Certificate of Appropriateness

Property 832 N. 29TH ST. Concordia Historic District
Description of work Replace broken windows with wood sash windows, Repair the gate in front of the drive way, Repair back porch, Add storm door to front and back doors
Date issued 5/27/2016 PTS ID 111144 COA

The appropriate newel.

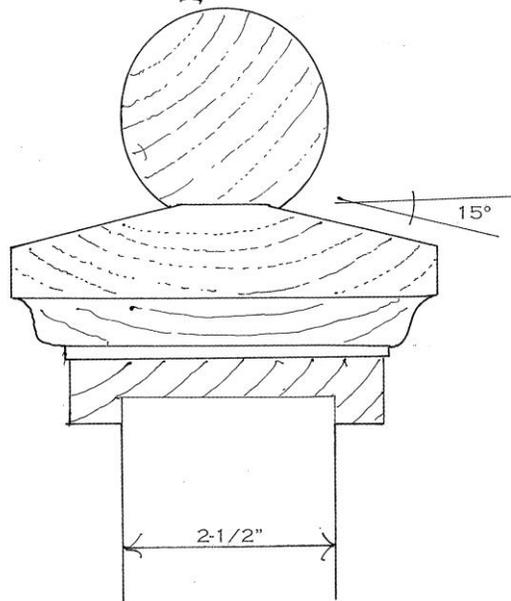
Stairs should be out of wood. Based on the State of Wisconsin Uniform Building Code, the rise or height of a step must not exceed 8 inches; however risers are most commonly between 7 and 7 1/2 inches high. Variations in height between porch steps should not exceed 3/16 of an inch. Any wooden porch post that is buried in or placed directly on top of soil should be pressure-treated. A typical porch post is a 4 by 4 or 6 by 6 post from of pressure-treated yellow pine, secured in a poured concrete footing. Newel nailed directly to the top of a porch step is subject to decay at the bottom and will generally be weak since it can easily pull loose. Bolting the newel to the inside of the stringer and cutting the treads to fit around the newel is recommended. A better method to bore a hole in the bottom of the newel to fit over a pipe that protrudes from a concrete footing beneath the stringer. You may choose to bolt the wooden stringer to the pipe as well. For the appropriate type of newel posts, see the attached images.

HANDRAIL/GUARDRAIL SECTION

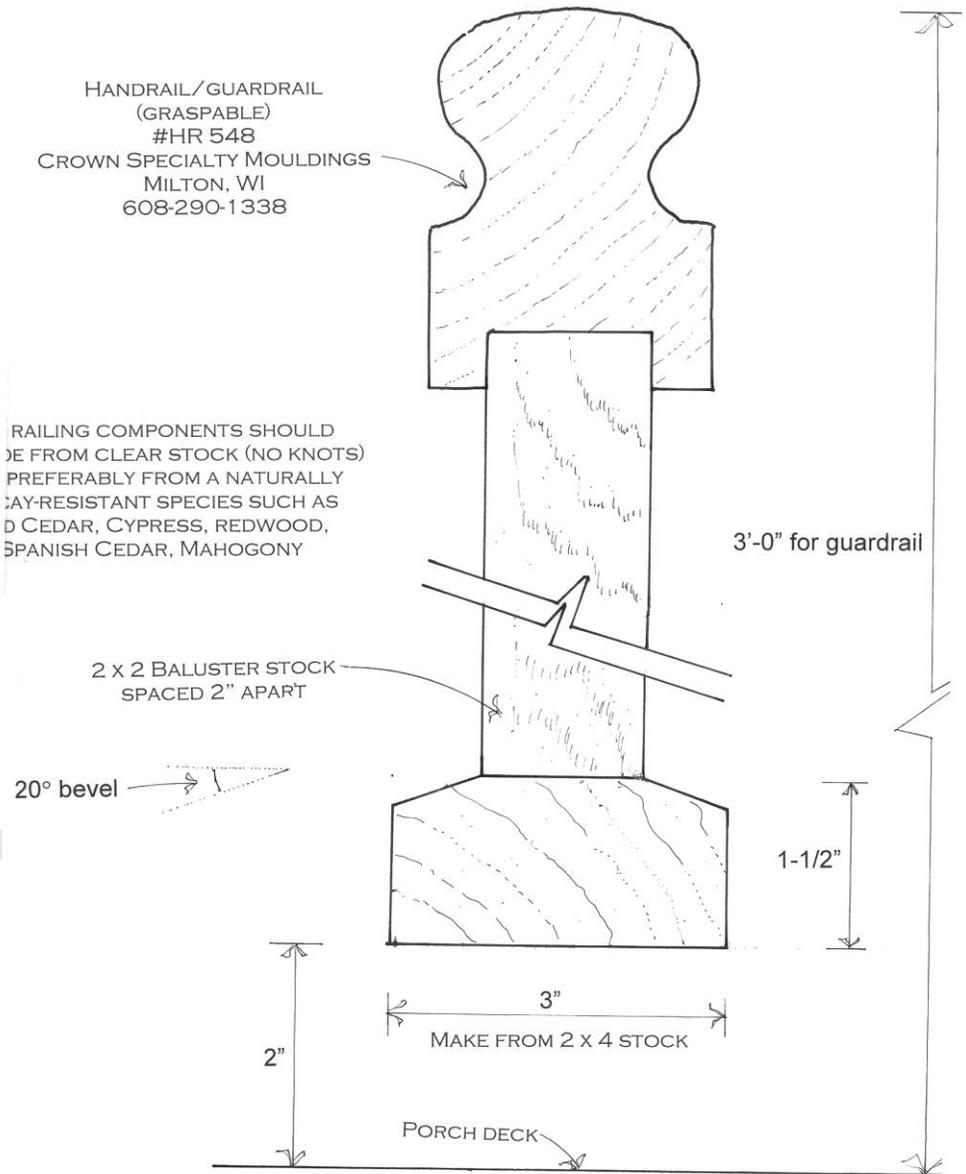
The upper rail on the guardrail and the handrail needs to be graspable and in a bread-loaf shape. The footrail (bottom rail) should be made of at least 2-inch-thick stock. The footrail should have tapered or sloped sides to shed water. In order to attach the handrails and footrails to newels and porch posts, using a special nutlike fastener called a Tite Joint® and a common metal dowel screw is recommended. Decks 24-inches or more above ground level must be equipped with guardrails as specified in the State of Wisconsin building code. For the appropriate type of railing, see the attached images. Current building codes require porch railings to be built to a height of at least 36 inches above the porch deck. Since building a railing more than 36 inch tall is generally not recommended for an older porch, 36 inches is an appropriate number to meet both the building code and historic preservation requirements. Spacing between spindles should be 3-1/2 inches on center. For the appropriate type of baluster, see the attached images.

RAILING COMPONENTS SHOULD
BE FROM CLEAR STOCK (NO KNOTS)
PREFERABLY FROM A NATURALLY
WEATHER-RESISTANT SPECIES SUCH AS
RED CEDAR, CYPRESS, REDWOOD,
SPANISH CEDAR, MAHOGONY

Two appropriate storm windows that might be used.

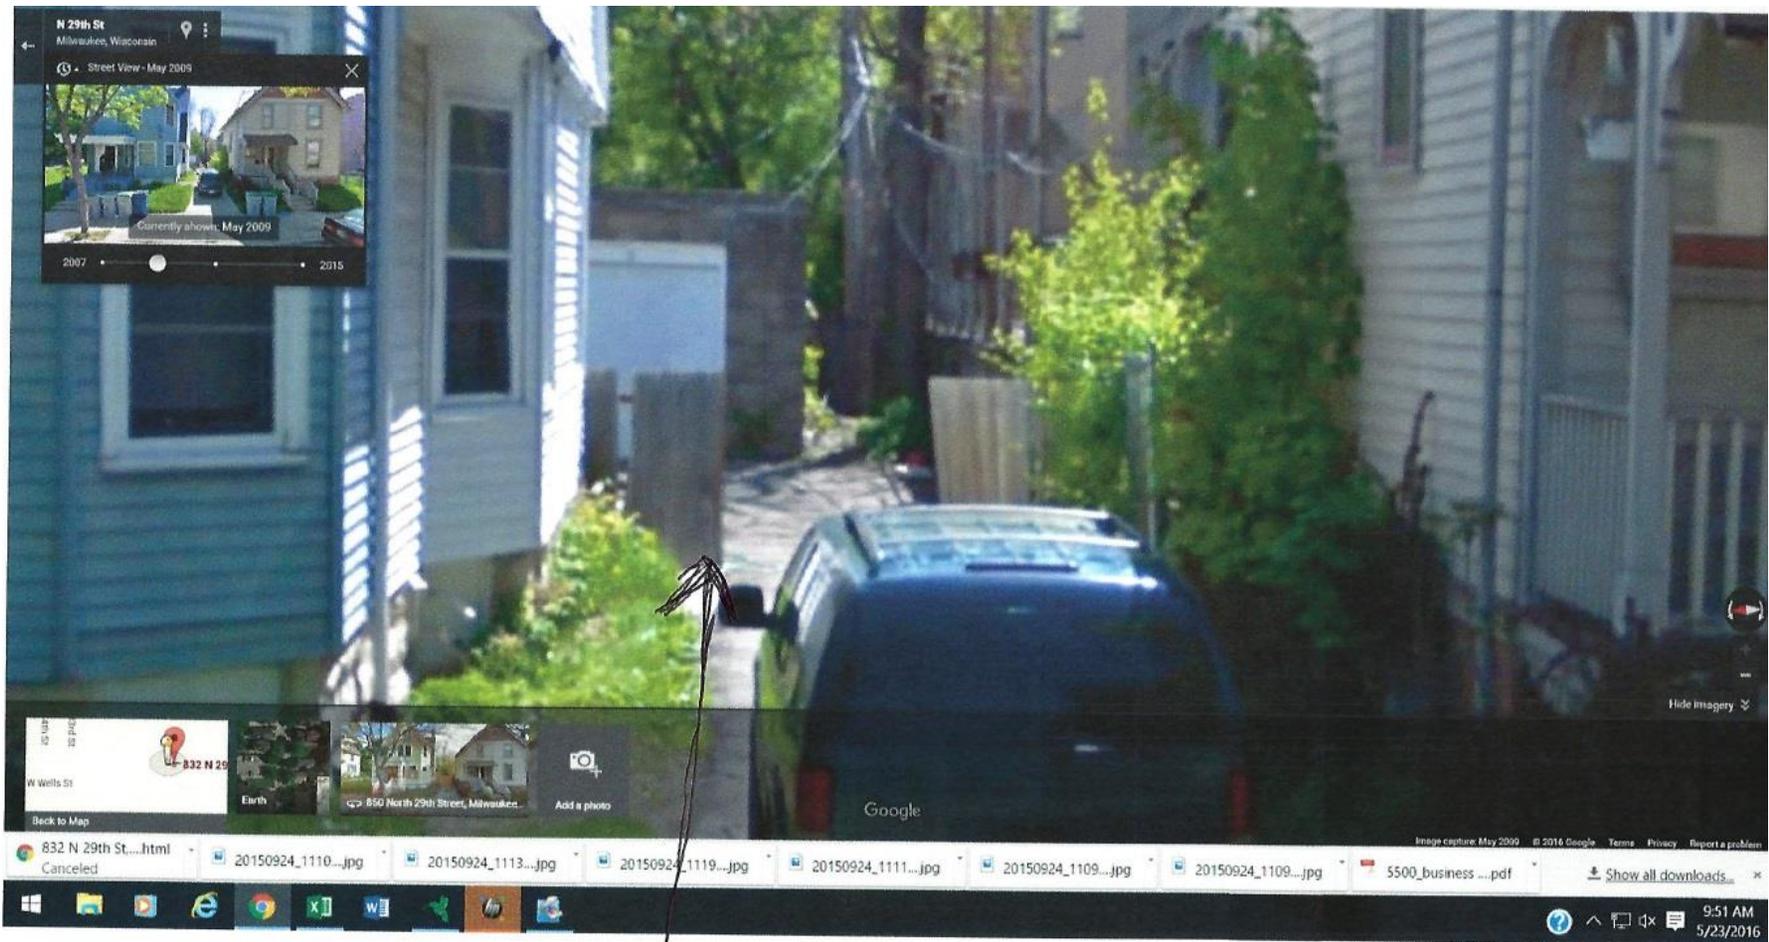
New wood storm doors will be installed in the front and rear of the house. For the appropriate types of storm doors, see the attached images.
